Comment on ACCC type conductors and ice load, SEC 2024-02 and DE-24-087

Figure 5: Sag Performance for Loaded Conditions

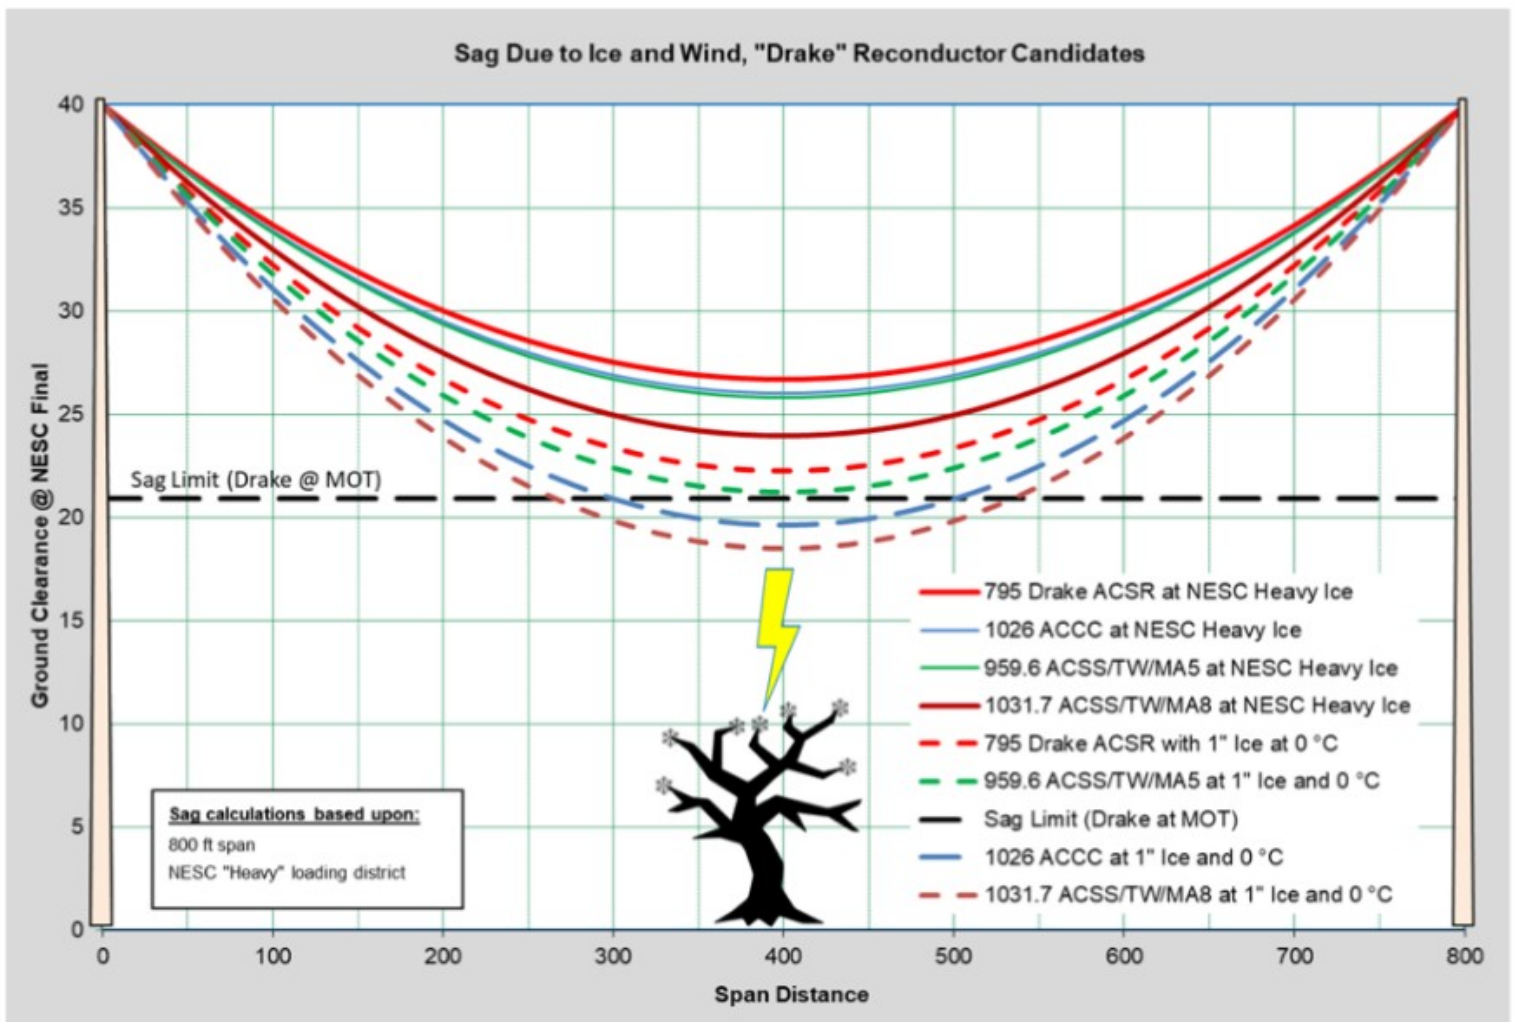
The [diagram](#) above indicates Eversource’s statement appears to be false.

1026 ACCC is shown as having 14’ sag at 800’ with NSC heavy ice load, comparable to the existing 795 ACSR Pheasant conductor

The closest ACCC type I can find is Southwire Gannet (ZTACCR/TW/C7 -TS) 1,116 1,945 amps

Where are Eversource profiles with ACCC type conductor, the typical (shorter than 800') spans on the X-178, structure heights below 60' (not subject to NESC heavy loading) and no ice?

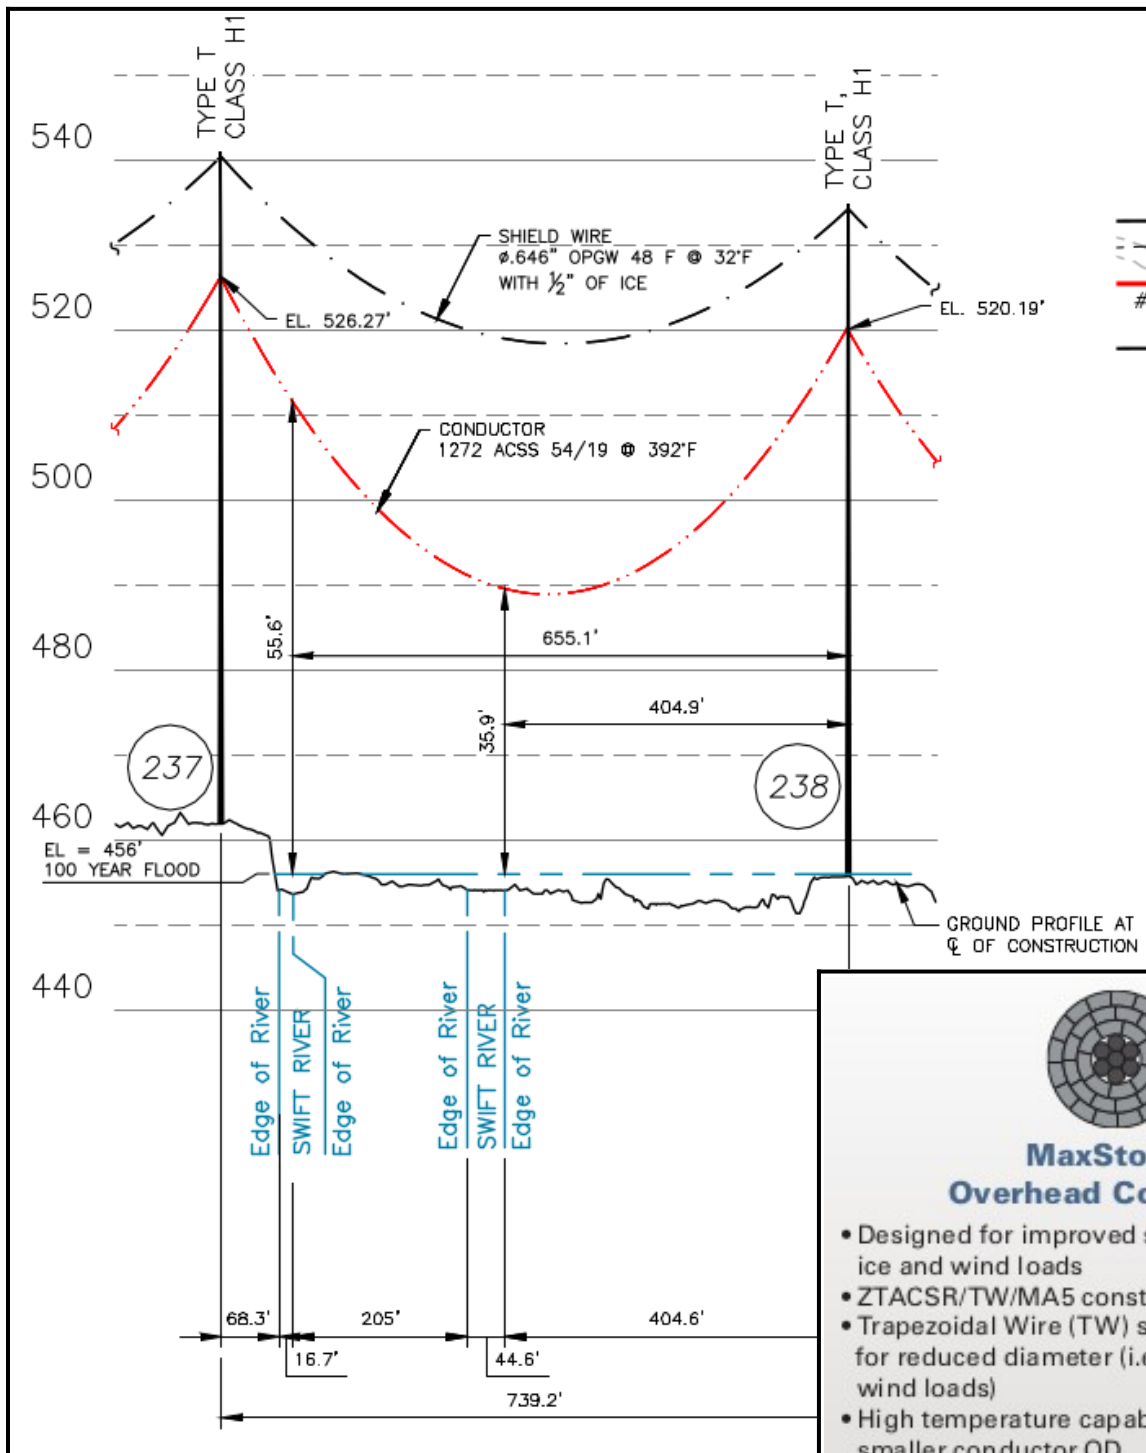
Below: Eversource's proposed 2,200 amp 1272 ACSS at 739' has 35' sag at 392 F, its condition of maximum sag, 20' more than the 1,026 ACCC with 1/2" radial ice.

Newer ACCC type conductors designed for ice loads may have even less sag. For example (above right) MaxStorm Overhead Conductor; “Trapezoidal Wire (TW) stranding allows for reduced diameter (i.e. reduced ice and wind loads.)”

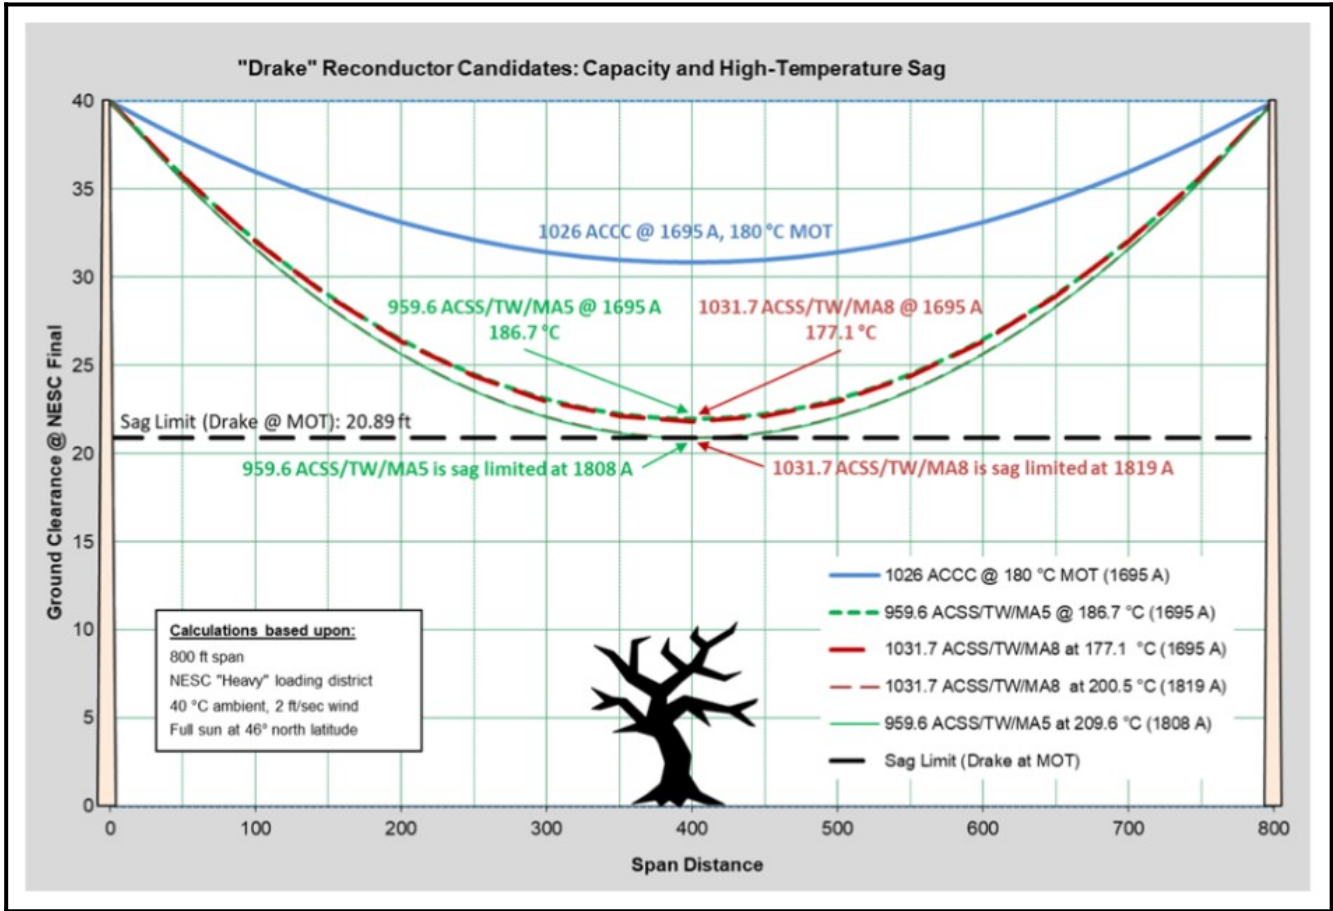
At the usual high temperature operating conditions, ACCC type conductor would sag far less than ACSS thus have less visual impact and be less subject to damage by falling trees.

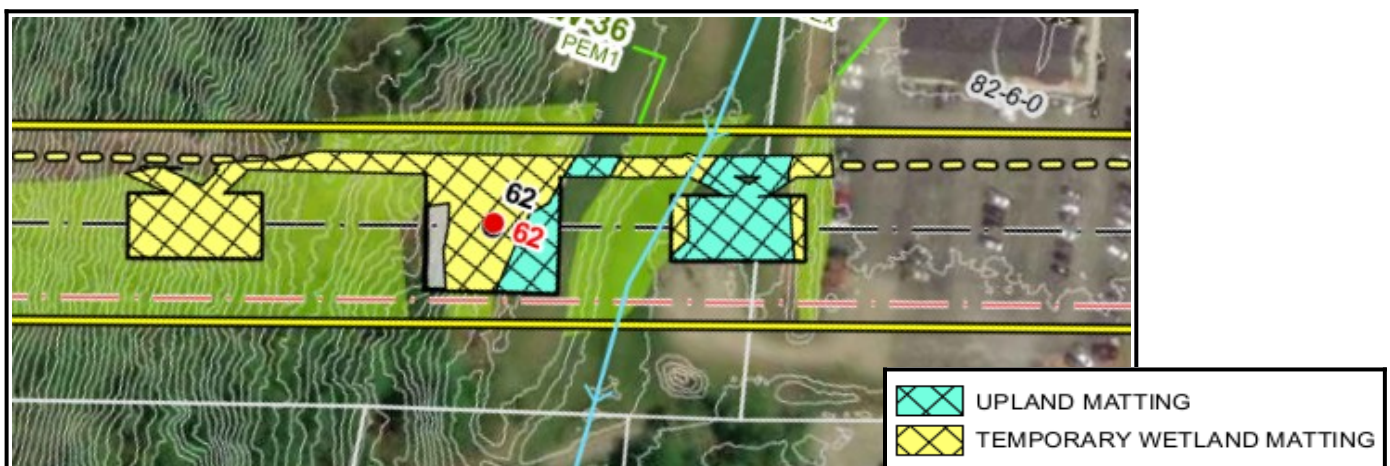
Loggers can fell and limb large trees with a tracked feller-buncher but Eversource claims it cannot set light-duty poles without a road and 100' x 100' construction pads. The plans for this area show wetland and uplands matting placed where the road and part of the lower construction pad are, so why has Eversource been allowed to excavate wetlands when it is required to place matting on the wetlands to protect them? Why has it built what appear to be two construction “pads” into the steep slope above structure 62 rather than laid wetlands/upland matting around it?

Should we assume Eversource is exceeding Code clearances and increasing structure heights here far beyond what is required to carry its high sag conductor, as it plans to do on the 49 miles of the X-178?
